# Statewide Utility CASE Team Responses to Stakeholder Comment Letters on the Proposed Title 24 Standards for Residential Lighting

Measure Number: 2016-RES-LTG1

Residential Lighting

February 26, 2015

**Figure 3: Low risk and no observable effect regions for flicker (Lehman et .a 2014) overlaid with region of graph not compliant with "reduced flicker operation" requirement**

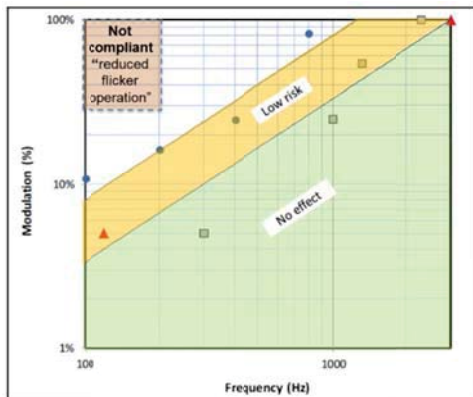
“Joint Appendix 10 and Flicker requirements: NEMA reaffirms its opposition to the CEC establishing its own mandatory flicker test procedures ahead of numerous industry working groups examining this phenomenon and working to identify repeatable objective tests to evaluate it. We caution against adopting the proposed test procedure in Joint Appendix 10 because it has not been adequately tested and it is not related to other, more advanced, efforts taking place in the IEEE and other scientific forums. The number of devices tested by the IOU/CASE team is woefully inadequate and the CEC is taking a significant risk by relying on such a small, unrepresentative data set. An IEEE document drafted and tested by an eminent scientific panel is currently in ballot. We appreciate the comments expressed by the IOU CASE team in which they attempted to downplay the potential confusion inherent in the proposed one-off test procedure. The Flicker Test Procedure in Joint Appendix 10 is not adequately vetted and should not be allowed to proceed into regulation; the draft Appendix should be struck.”

Title 24 has had the same requirements for “low flicker operation” of dimming controls since the 2008 Standards. This requirement pertains to dimming sources controlled by dimming controls that have less than 30% amplitude modulation for frequencies less than 200 Hz. As described in the Residential Lighting CASE Report, this requirement is less stringent than the proposed flicker guideline in IEEE PAR 1789. Figure 3 from the CASE Report is included below.<sup>3</sup> Though the California “low flicker operation” requirement is less stringent than setting a standard at what is not considered to be high risk,

we believe that once flicker is quantified and published in a CEC flicker database that manufacturers will voluntarily design to even lower amounts of flicker. Thus, the proposal does not require more stringent flicker requirements than what have been in place for a while. However, the proposal does recognize that flicker is not just a function of the control but also of the light source and its driver or ballast.

NEMA appears to support a more stringent flicker standard, such as IEEE PAR 1789. However, NEMA has expressed their opposition regarding a flicker test method and, although many of their members are required to conduct flicker testing as part of their ENERGY STAR certification, NEMA has not yet been able to provide any data on the “one-off test procedure.” NEMA claimed that the standard was not repeatable. The CASE Team provided results from round robin tests between two labs that showed repeatability of the test standard.

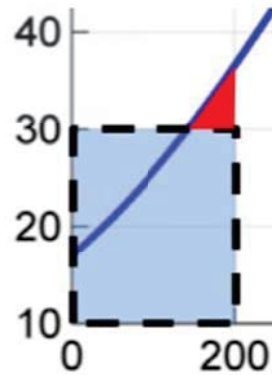
The Title 20 specification on flicker is overly restrictive for some frequencies and too lax for others. It states:

This specification makes no allowance for the dependence of human flicker sensitivity either on frequency or on wave shape. For sine wave modulation, the visibility threshold for stroboscopic effects<sup>1</sup>, expressed in terms of modulation depth, is shown in the figure below. At a particular frequency, modulation depths above the curve can be detected by most people. Below the curve, they are not detected by most people. The threshold changes for different wave shapes, in a way that depends on the Fourier components of the light output waveform. A full Fourier approach would take account of both frequency and wave shape effects<sup>2</sup>. Sensitivity to flicker also depends on the application. Flicker in outdoor street lighting or in stairwells is more tolerated than in indoor offices, for instance. Therefore, a curve of *acceptability* may be above the *visibility threshold* curve. Different curves may be needed for different applications.

Zooming in on the region from 0 to 200 Hz in the figure above, the shaded rectangular region with dashed outline represents the conditions allowed by the Title 20 specification. The red triangle is forbidden by the Title 20 specification, but flicker in this region is not visible to most observers. Title 20, as a MINIMUM specification, should not exclude acceptable regions where flicker is not even be detected.

**Figure 3: Low risk and no observable effect regions for flicker (Lehman et .a 2014) overlaid with region of graph not compliant with "reduced flicker operation" requirement**

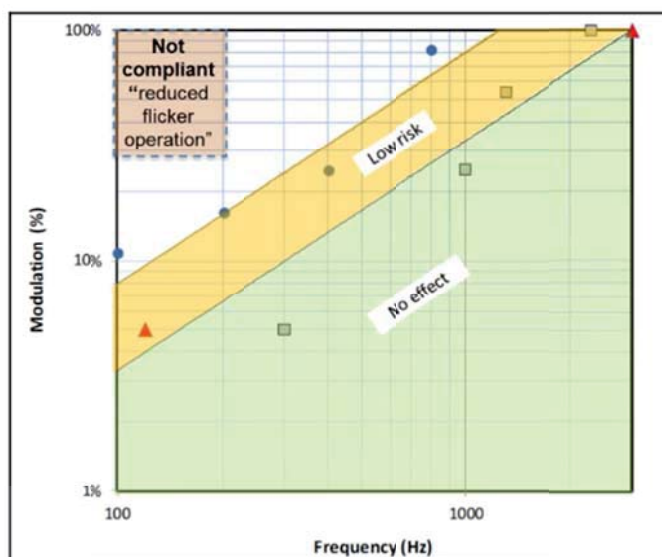
If CEC is unwilling to remove the flicker specification and wait for agreement in standards organizations, then CEC should at the very least modify the present specification to allow use of

the acceptable flicker region denoted by the red triangle in the figure above. We suggest modifying the specification to allow flicker in the region shown in the figure below. The specification would then be:

Second, the Philips comment seems to be conflicted. On the one hand, the comment suggests that the proposed flicker standard is too stringent, and that it should be relaxed between the frequencies of 100 – 200 Hz to allow products that produce some visible flicker. On the other hand, the comment encourages CEC to coordinate with the IEEE “experts” who are working on a flicker standard currently. In fact, the CASE Team has worked quite closely with several members of the IEEE PAR 1789 committee who are working on a flicker standard for LEDs currently. The standard being developed by that committee is actually far more stringent than the standard being proposed in California. Members of the IEEE PAR 1789 committee have submitted comments to the CEC urging California to adopt a *more* stringent standard level.

As described in the Residential Lighting CASE Report and shown in the figure below, the requirement being proposed now would only prohibit levels of flicker that are the most offensive. Levels of flicker that are considered “low risk” (the yellow area) would be allowed by the current proposal, as would a great deal of flicker that has some higher level of risk (the white area).

Philips also suggests in its comments that the proposed test procedure does a poor job of determining flicker acceptability. First, the role of the test procedure is not to determine acceptability, the role of the test procedure is simply to measure levels of flicker. Second, the proposed JA10 test procedure has received support from multiple stakeholders, including other manufacturers and two members of the IEEE PAR 1789 committee, for whom Philips would like the CEC to wait.
